## Village of Greenport Building Department

### NOTICE OF DISAPPROVAL

PLEASE TAKE NOTICE that your application dated January 29, 2024 and plans dated January 2, 2024 proposed 2 story addition with wood deck at existing property located at 218 Sixth Street, Greenport NY 11944 in the R2 District, is returned herewith and disapproved on the following grounds:

DWG. NO A-1

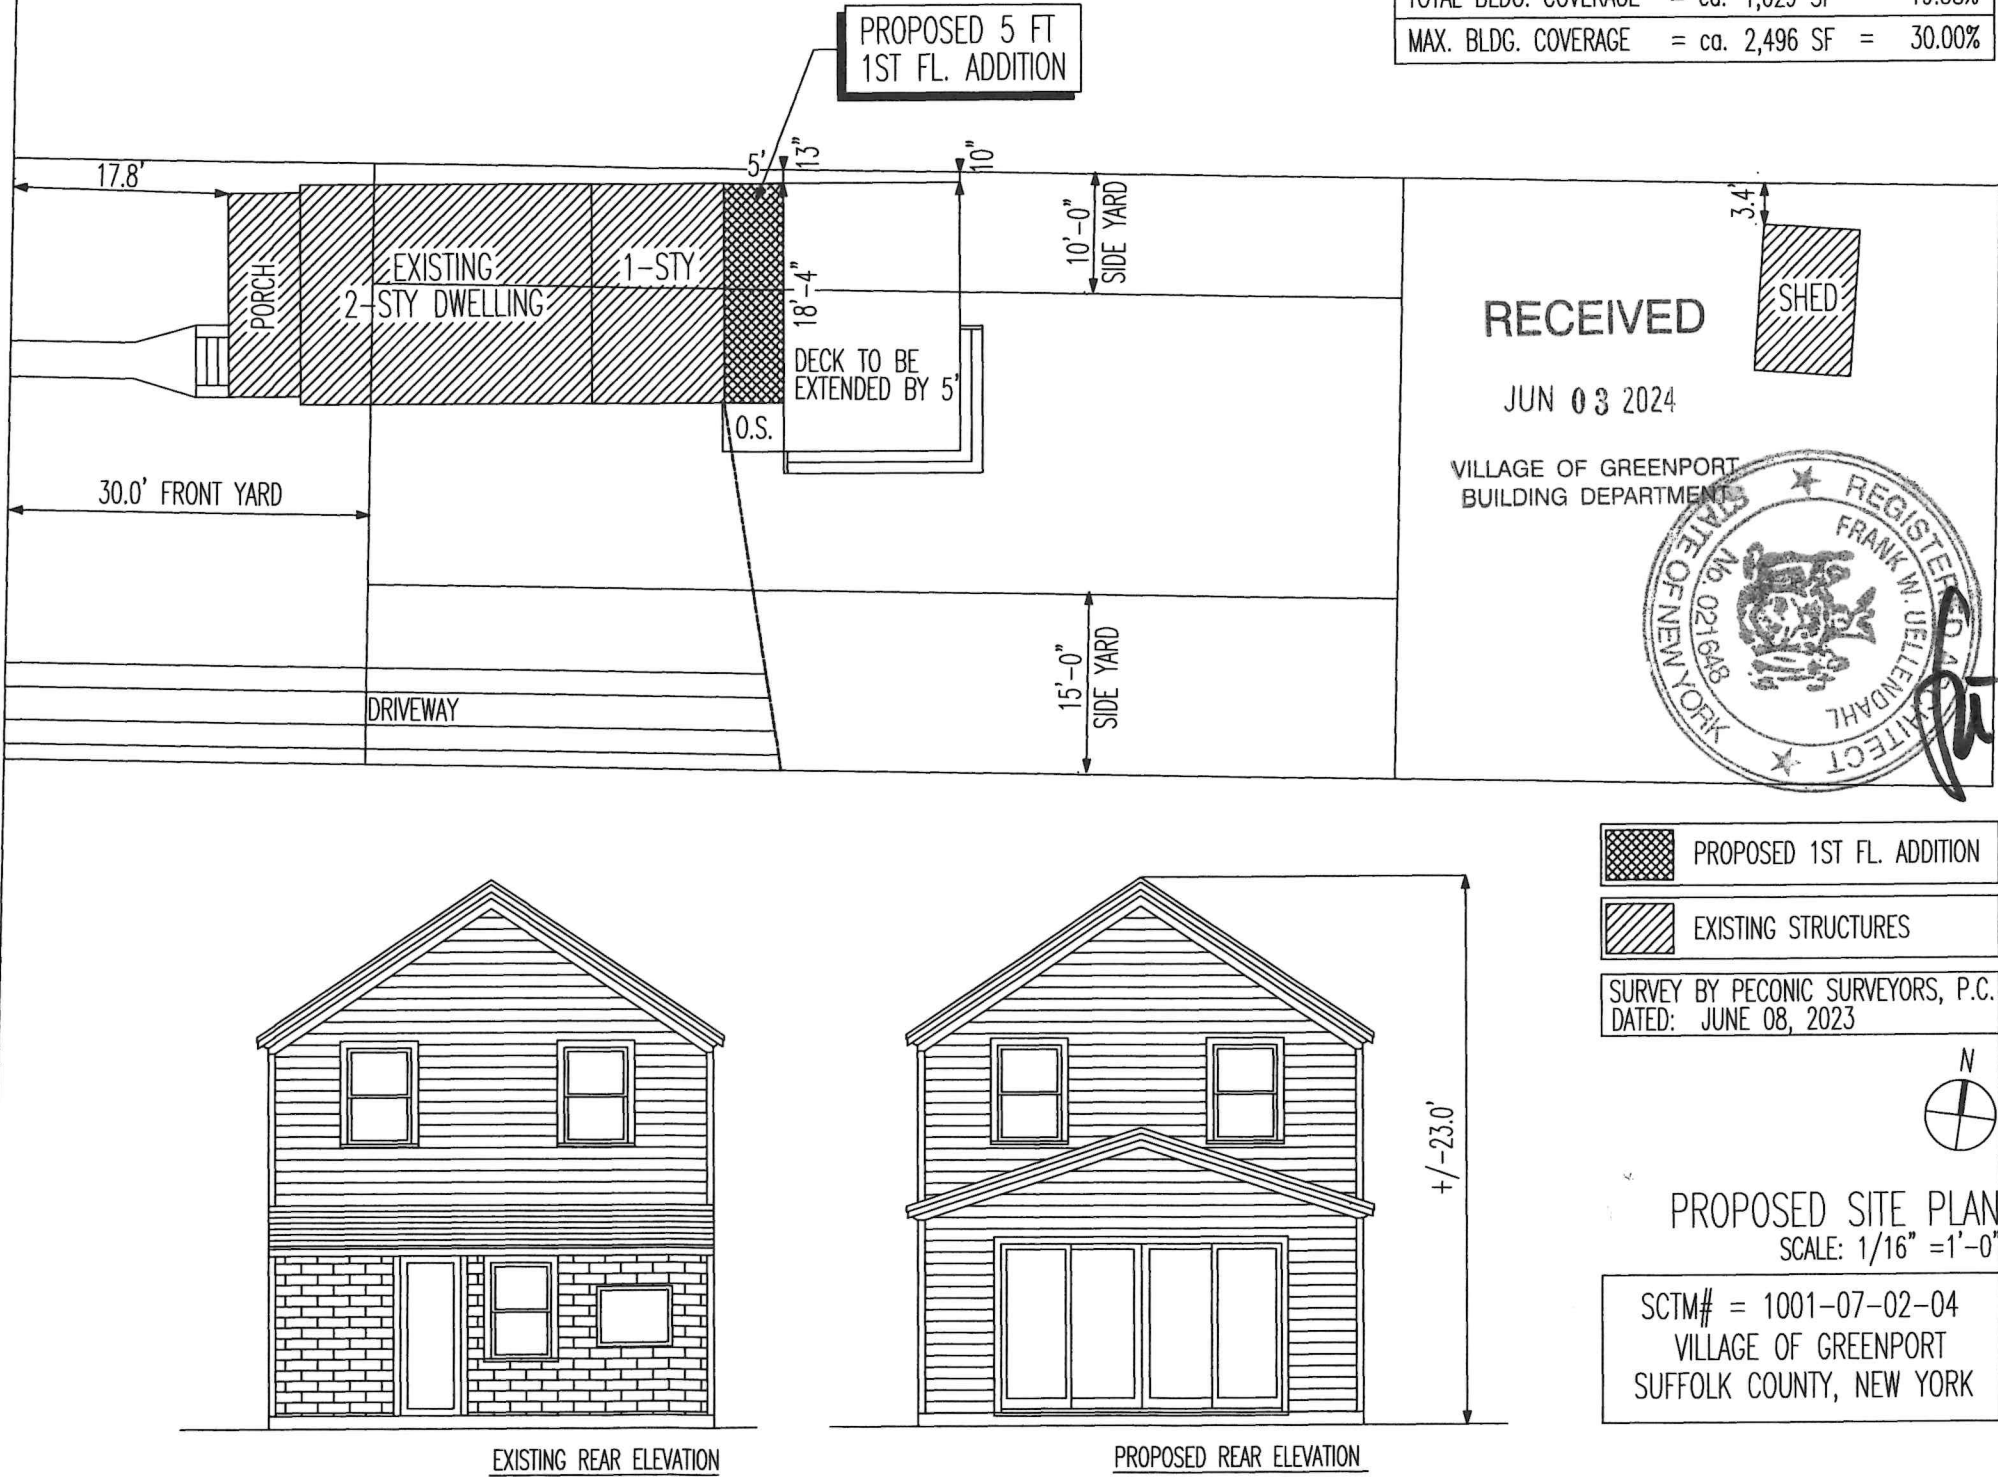
#### **1) Front Yard Setback Requirements.**

##### 150-12 Schedule Regulations

R-2 District: Minimum Front Yard Requirement: 30 feet.

The plans show the front yard setback of 17.8 feet.

This would require an area variance of 12.2 feet.

#### **2) Side Yard Setback Requirements.**

##### 150-12 Schedule Regulations

R-2 District: Minimum Side Yard Requirement: 10 feet.

The plans show the side yard setback of 1 inch.

This would require an area variance of 9.9 feet.

#### **3) 150-13 Residence district regulations.**

A. Accessory buildings (b) Such building shall be set back five feet from any lot line and shall not be located less than 10 feet from the principal building.

The plans show a accessory building 3.4 feet from the property line.

This would require an area variance of 1.6 feet.
